TECHNICAL BULLETIN

Product: 3 ways to tell a MKR 372 from a MKR 371
 Effective Date: July 2, 2021
 Part Affected: MKR 372 (F1901110, F1901120, F1901130, F1901140, F1904205)
 MKR 371 (F1900010, F1900020, F1900030, F1900040, F1904210)
 Issued By: Ivor Lewis, Product Manager

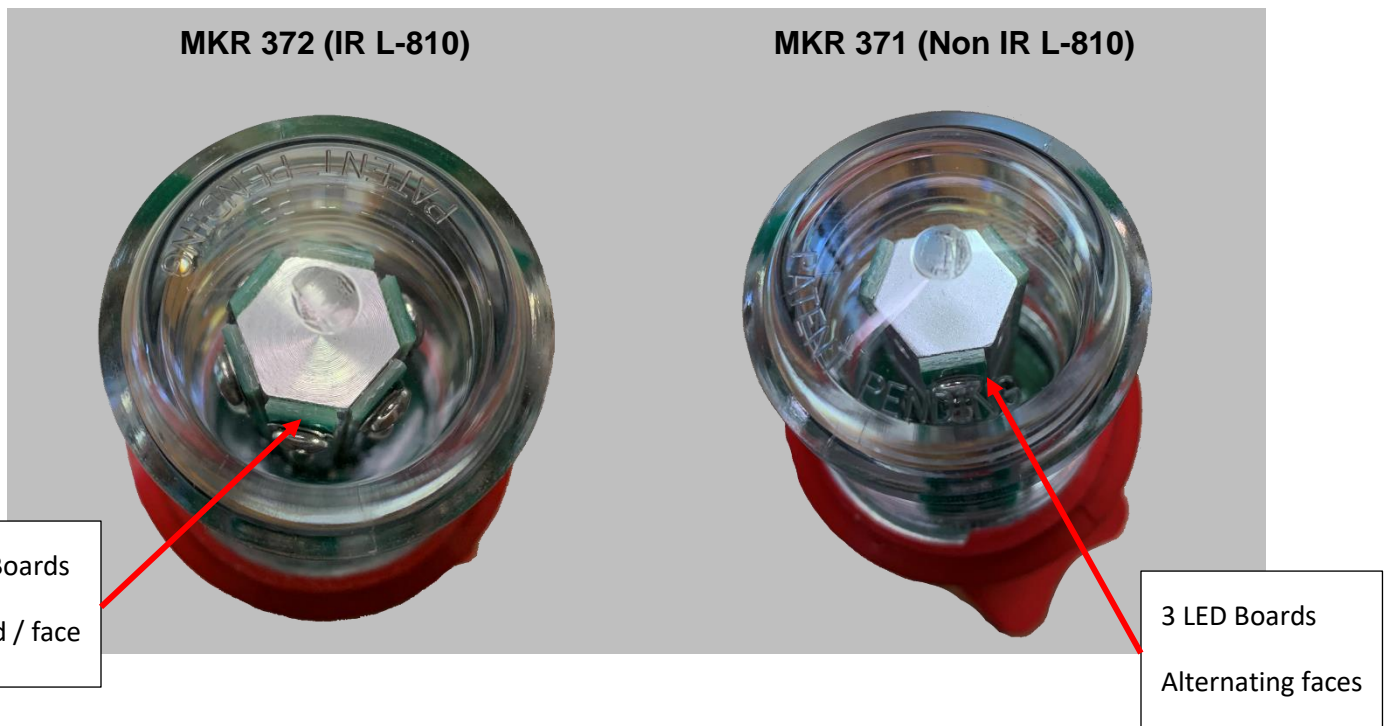
1. Each marker has a label on its side identifying the product.
2. If the label is missing, look at the L-810 marker from the top (shown above).
 - a. MKR 372 will have LED boards on **every** side of the central hexagonal conductor (6 boards)
 - b. MKR 371 will have LED boards only on alternating faces of the central hexagonal conductor (3 boards).
3. Install L-810 marker, check MKR A2D values and call Flash Tech Support at 800.821.5825, option 9.
